Grand Haven Charter Township Planning Commission
Thursday, May 28, 2020 – 6:00 p.m.
(after the ZBA meeting adjourns)
Remote Electronic Meeting

RE: Site Plan Review – GHCM – New Construction of Warehouse

DATE: May 22, 2020
TO: Planning Commission
FROM: Stacey Fedewa, AICP – Community Development Director
RE: Minor PUD Amendment – Lakeshore Flats Apartments – Entrance Sign

RE: Apartments at Robbins Rd – PUD – Staff Review Comments No. 2

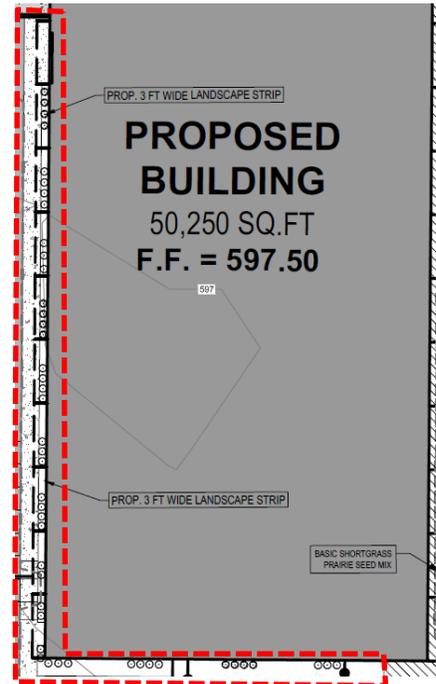
2. Steeper slopes for the stormwater basin.

Sloping for the proposed stormwater basin include slopes measuring 4:1. The Zoning Ordinance allows for a maximum slope of 5:1. The request is in relation to the Township requirement to preserve landmark trees and the ability to meet site drainage requirements.

1. South Elevation

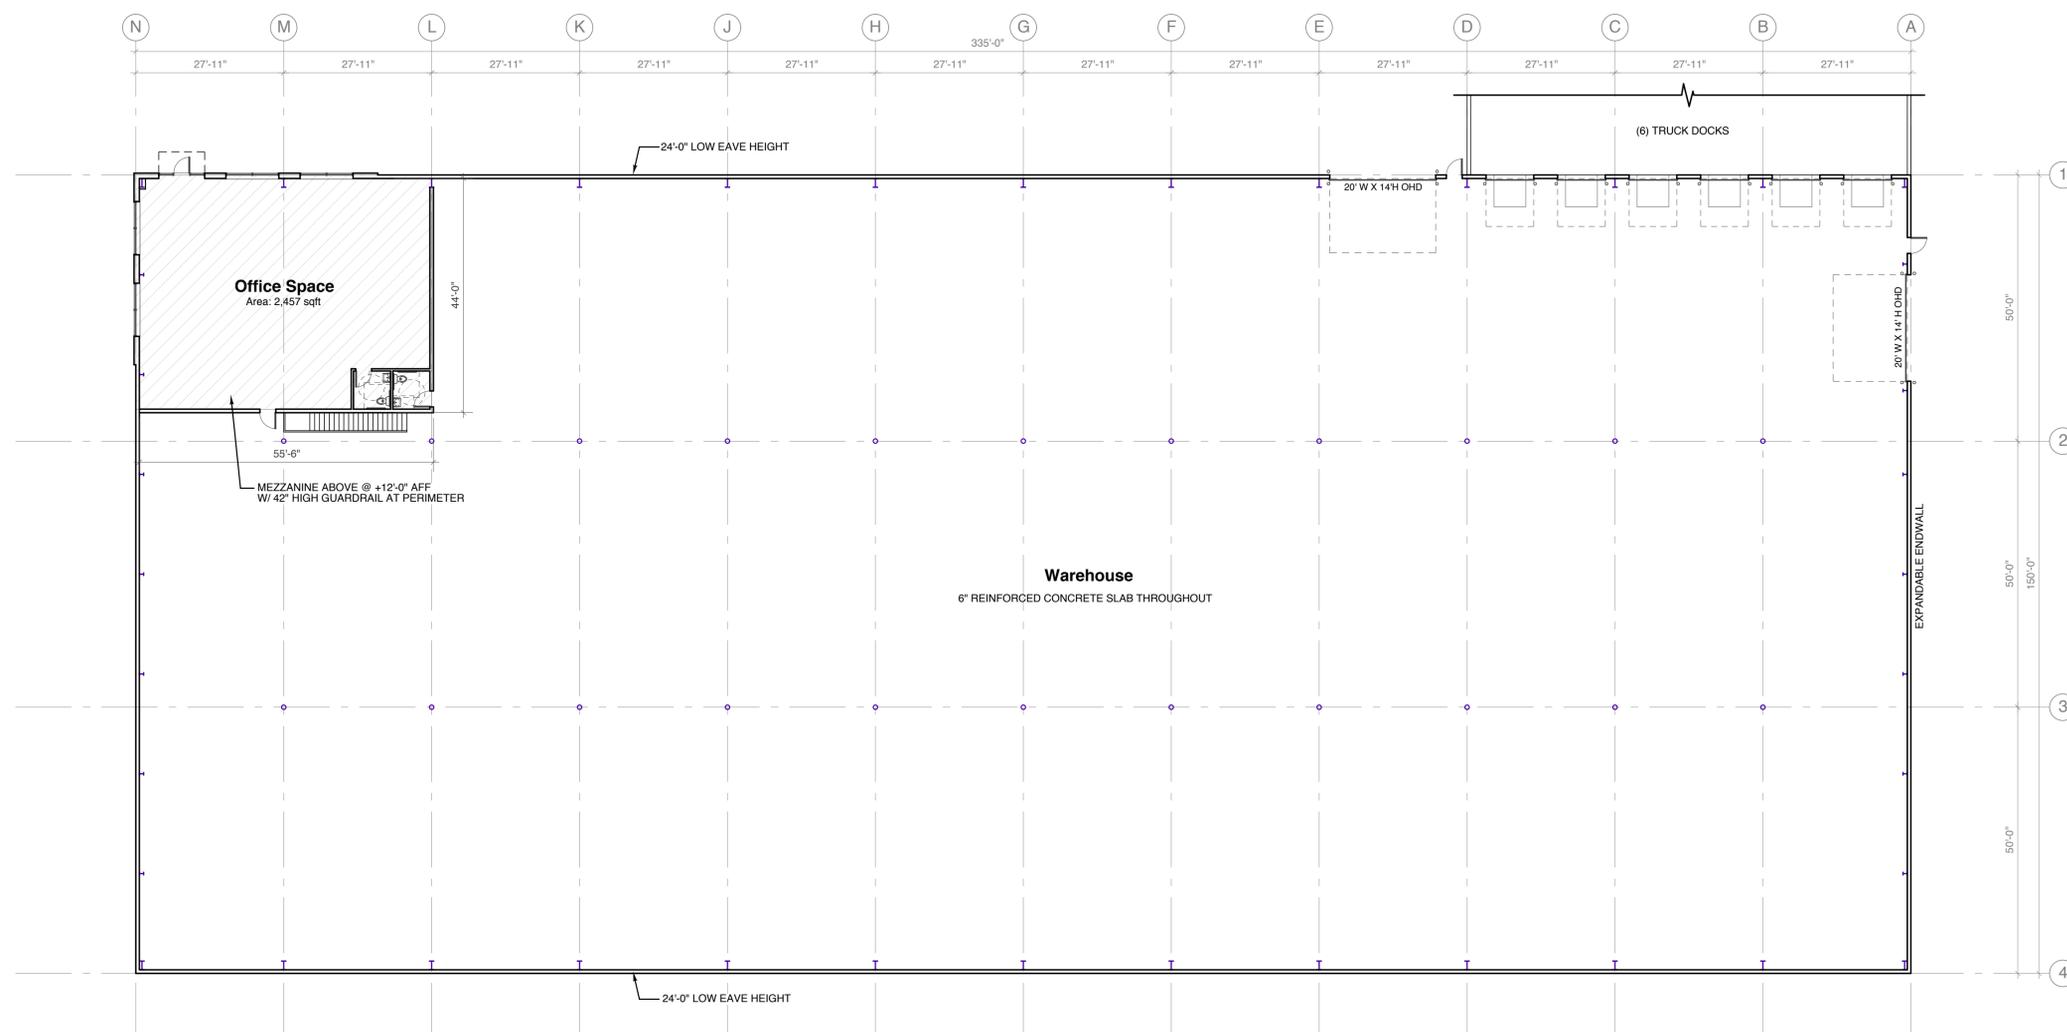
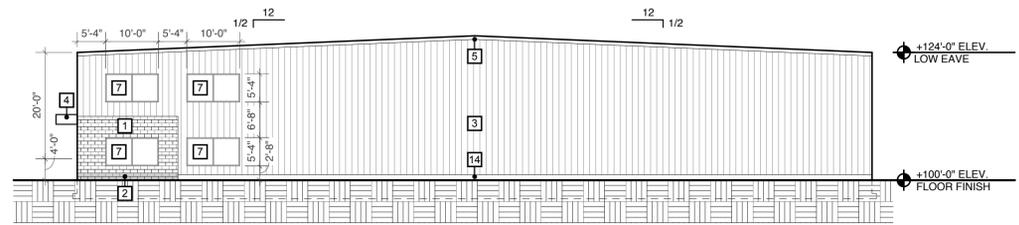
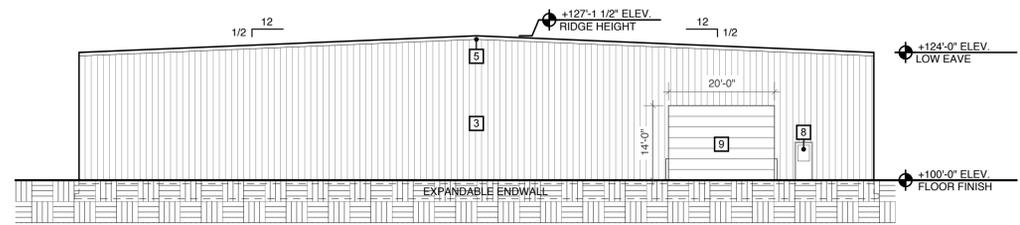
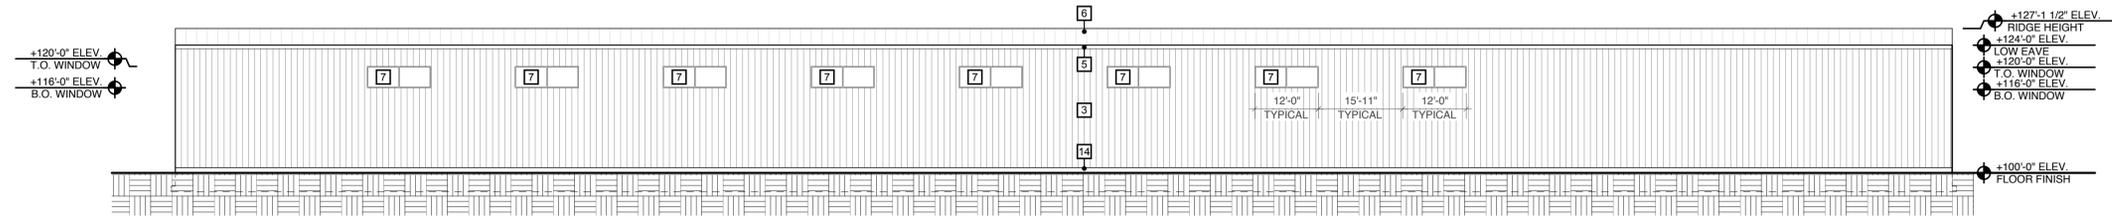
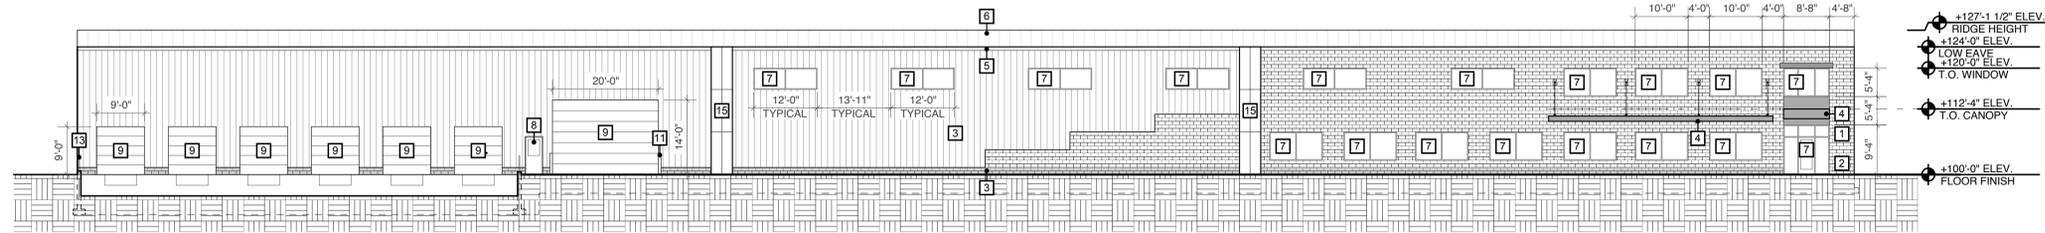
The Planning Commission determined additional architectural features would be needed to fulfill the Overlay Zone design standards. The applicant has provided updated elevations which feature additional brick along the front of the building and two red block stripes. **Is the Planning Commission satisfied with the proposed building elevations?**

1. Revised building elevation plans shall be submitted prior to a building permit being issued.
2. Must receive approval from the Ottawa County Road Commission and Ottawa County Water Resources Commission prior to a building permit being issued.
3. *List the conditions.*

Exhibit A: Proposed Sign Design (1 of 1)

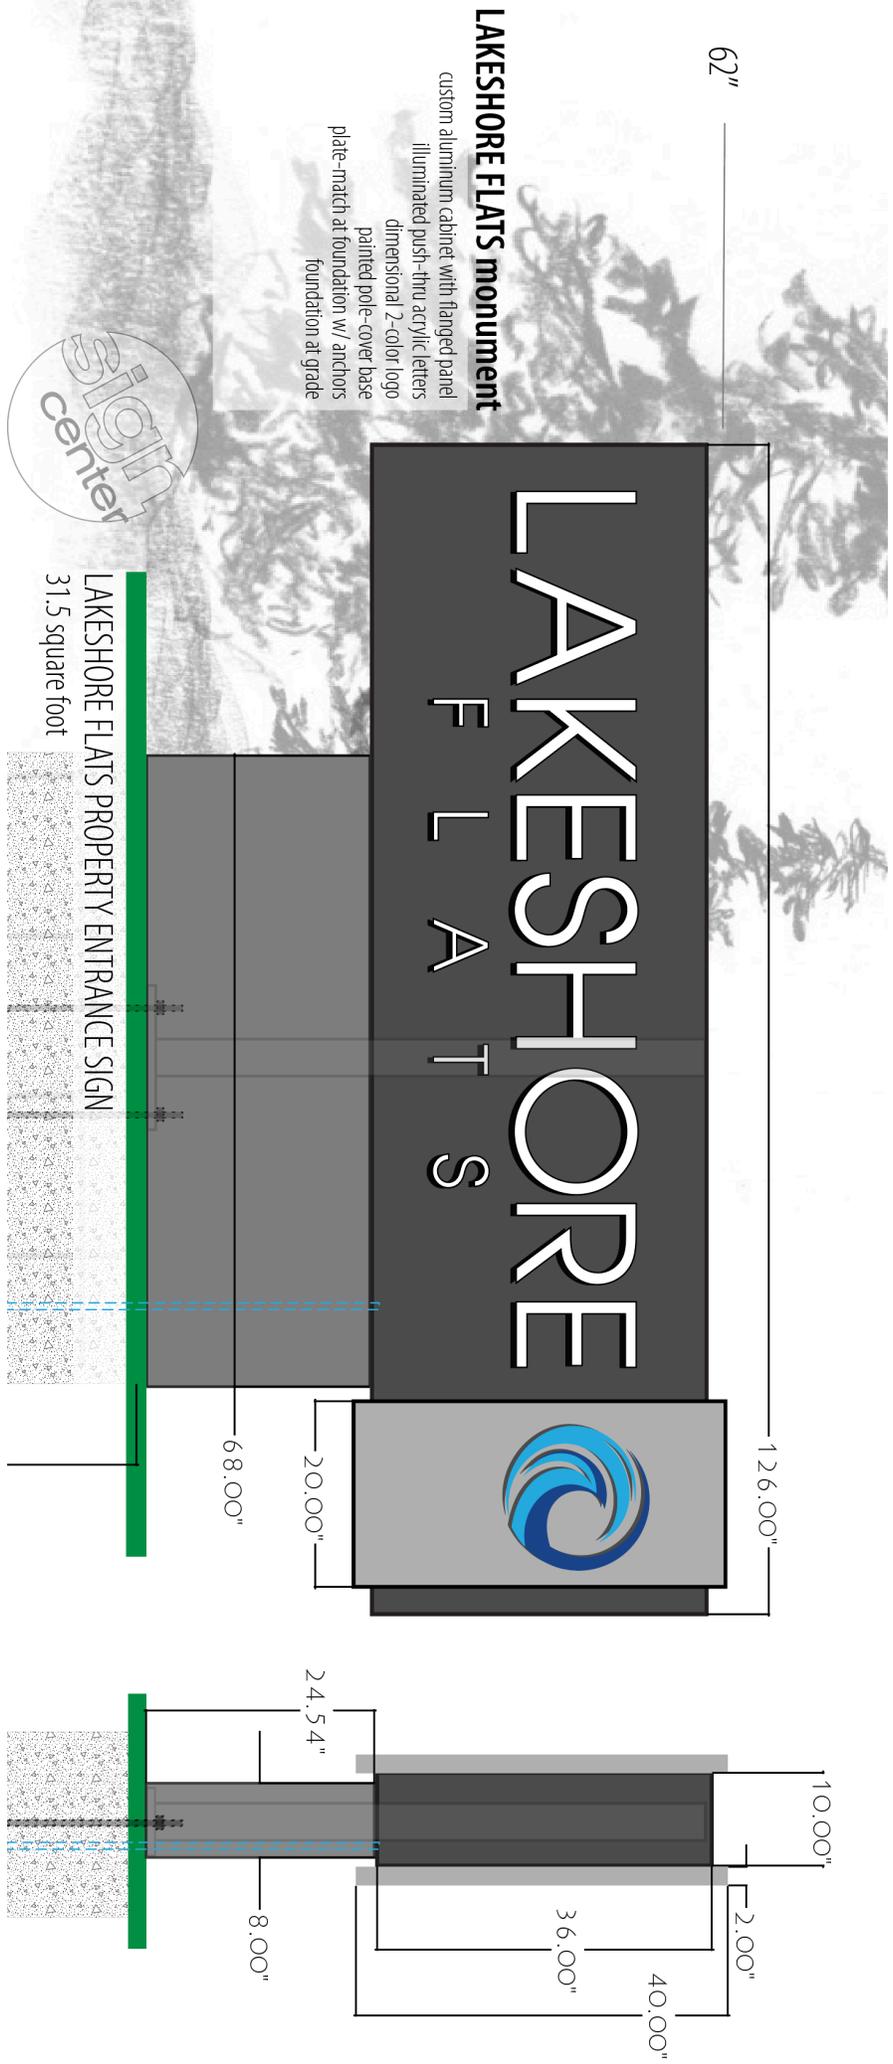
The approved sign is attractive and can easily be modified to address the developer's concerns—replace the compass with the circular/wave design that has been created for the Lakeshore Flats and change the “irregular and uneven” top of the stone to a different shape if desired.

Staff recommends the Planning Commission deny the Minor PUD Amendment request and require the developer to install the approved entryway sign that can be tailored to fit the Lakeshore Flats identity.
